## PRODUCT / PROCESS CHANGE NOTIFICATION

1.1 Company	 STMicroelectronics International N.V
1.2 PCN No.	MDG/23/14327
1.3 Title of PCN	STM32H562xGx & STM32H563xGx - FLASH memory configuration fixed on 1MB listed products
1.4 Product Category	STM32H562xGx, STM32H563xGx
1.5 Issue date	2023-12-06

### PCN14327 – Additional Information

### **STM32H562xGx & STM32H563xGx - FLASH memory configuration fixed on 1MB listed products.**

**Table describing the changes:**

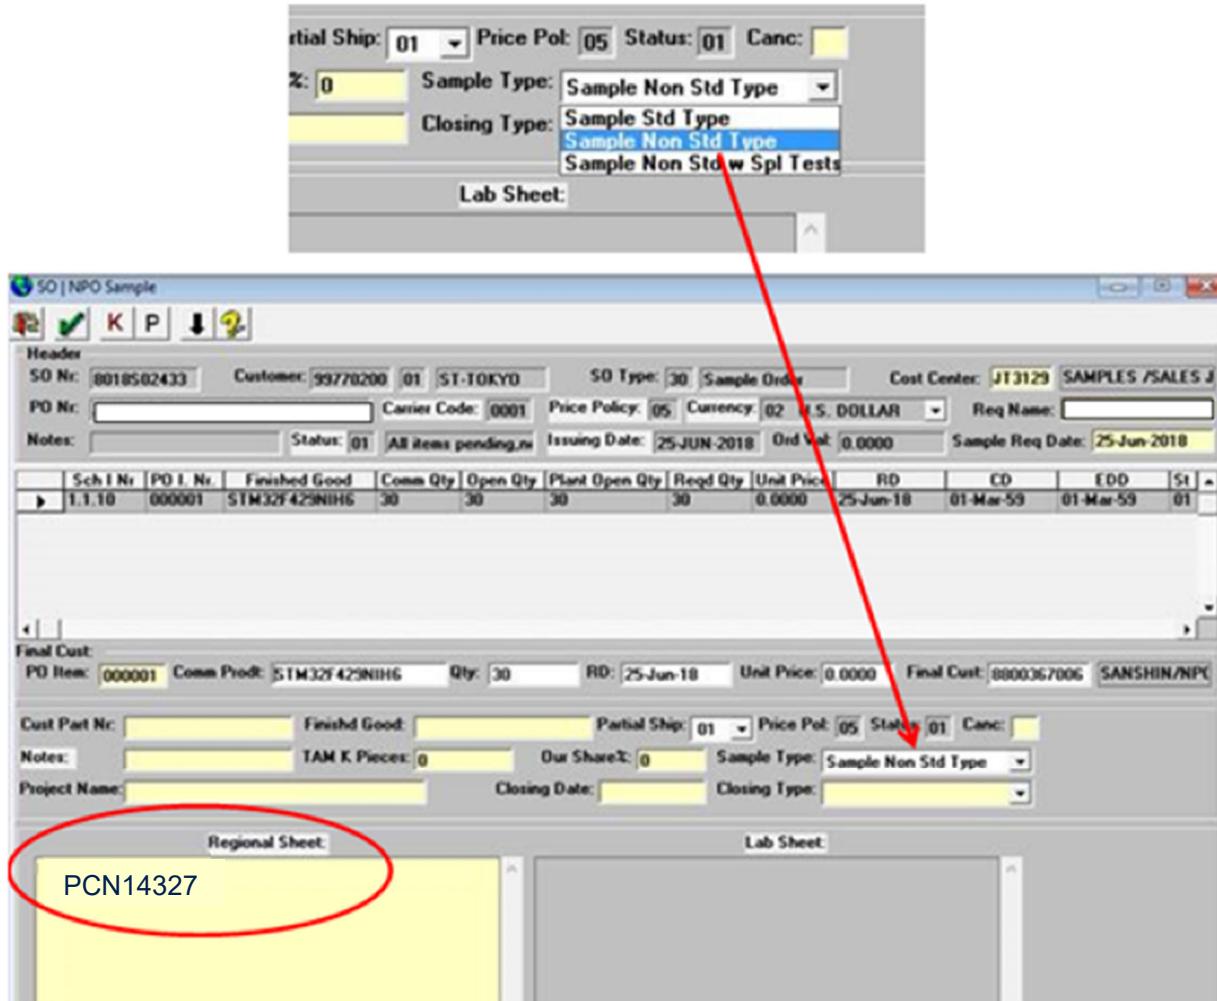
1-Mbyte part numbers (STM32H562xG and STM32H563xG with a date code earlier than week 35 2023) are not correctly configured to support the two 512-Kbyte flash memory banks. Instead, the flash memory configuration is set to 2 Mbytes (two 1-Mbyte banks). The incorrect configuration can be identified by reading the bootloader version (at address 0x0BF9 FAFE): it returns the value 0xE4 (2-Mbyte configuration), while it is 0xE5 for the correctly configured part numbers. Bootloader (BL) and System FLASH Security Package (SFSP) have changed due to Debug Authentication (DA) issue on 1MB products.

Only a few Finished Goods (FG) have been codified with wrong settings (see table below).

- The customer can detect the change by reading the new version of SFSP version 2.6.0 (0x02060000) from address “0x0BF960CC” and new BL version 14.5 (0xE5) from address ‘0x0BF9FAFE’
